12
13 HEARING ON THE MATTER OF
CALIFORNIA DEPARTMENT OF WATER
14 RESOURCES AND UNITED STATES
BUREAU OF RECLAMATION REQUEST
15 FOR A CHANGE IN POINT OF DIVERSION
FOR CALIFORNIA WATER FIX.

**PART TWO TESTIMONY OF
STEFFEN MEHL**

Figure 1. Cumulative difference in Sacramento River leakage volume within the South American Subbasin: CVHM No Action Alternative minus Alternative 4

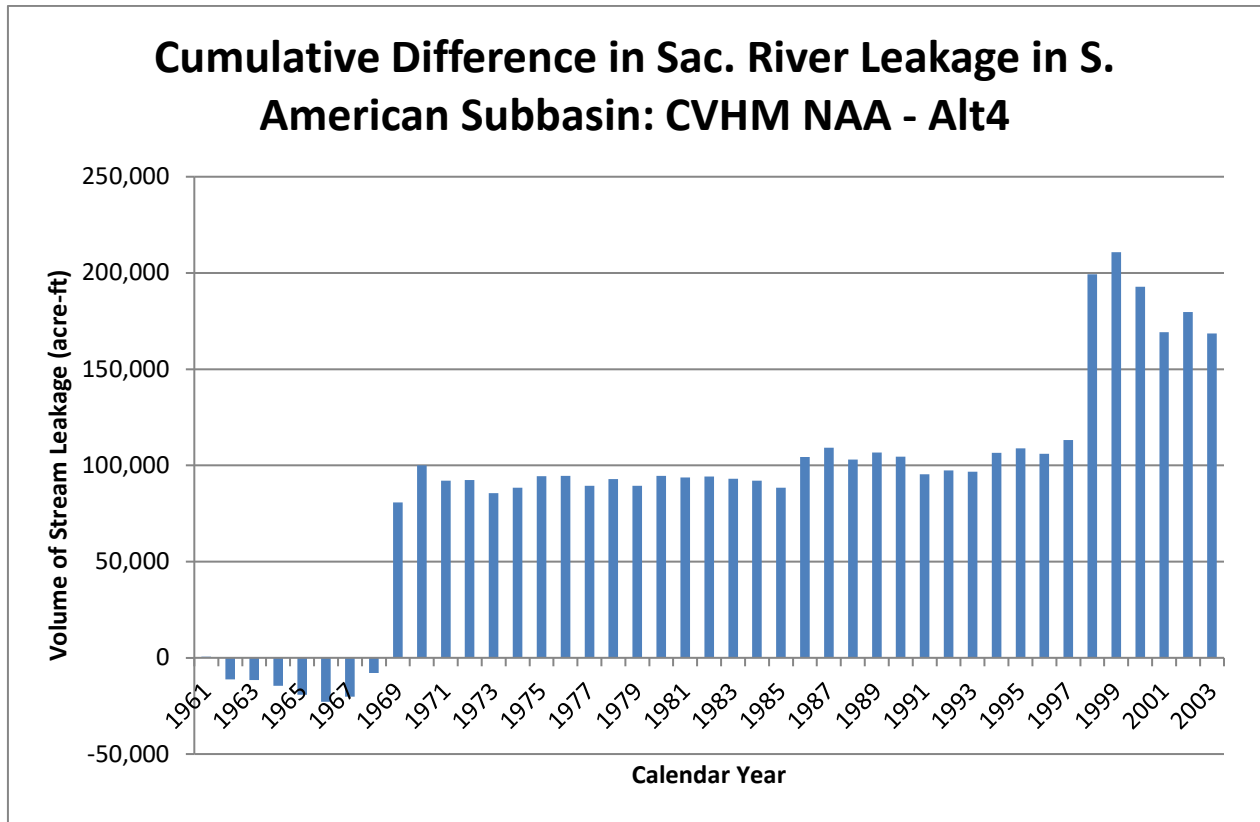
14 Without making any modifications to the CVHM NAA and Alt4 models, water
15 budget results for the South American Subbasin and for the Sacramento River
16 specifically were extracted, post-processed, and water budget terms were compared
17 between the NAA and Alt4. As presented in Figure 1 (below), the implementation of
18 CWF could affect the water budget of the entire South American Subbasin and not just
19 the area in the vicinity of the diversion. As mentioned in previous testimony, I am aware
20 that there are issues with DLEAK that can cause erratic model results (Exhibit SCWA-
21 200, paragraph 17.) These results should not be considered as absolute numbers but an
22 indication of the possible relative changes caused by the CWF operations. Conclusions
23 include:

- 24 1) Differences in leakage on the Sacramento River adjacent to the South
25 American Subbasin may reach up to 200k acre-ft when looking at the
26 cumulative differences between CVHM-NAA and CVHM-Alt4. Although the
27 models used by the Petitioners were not developed to focus on stream-aquifer
28 interaction, the area around the Sacramento River has substantial stream-

- aquifer interactions that can be significantly affected by CWF operations.
- 2) The cumulative difference in stream leakage along the Sacramento River is negative for the first 5 or so years and then the difference becomes positive. I previously noted that the years 1968-69 and 1998-99 are affected by possible numerical errors. Besides these critical changes in the cumulative difference in the leakage, there are other years with significant variation and this supports the conclusion that 5 years of monitoring data is not enough in the sense that there is a lot of variability in this system and in California hydrology in general. For example, in terms of California hydrology, 2013 was one of the driest years on record while this year was the wettest. Long-term monitoring should be done in conjunction with modeling to support and test model accuracy and to separate out what is natural variability versus the impacts due to CWF operations.

- 3) This concern needs to be aligned with the acknowledgement that the Groundwater Sustainability Agencies (GSAs) implementing SGMA must show sustainability over a 20-50 year period. The CWF has the potential to impact aquifer sustainability and therefore should monitor for at least 20 years.
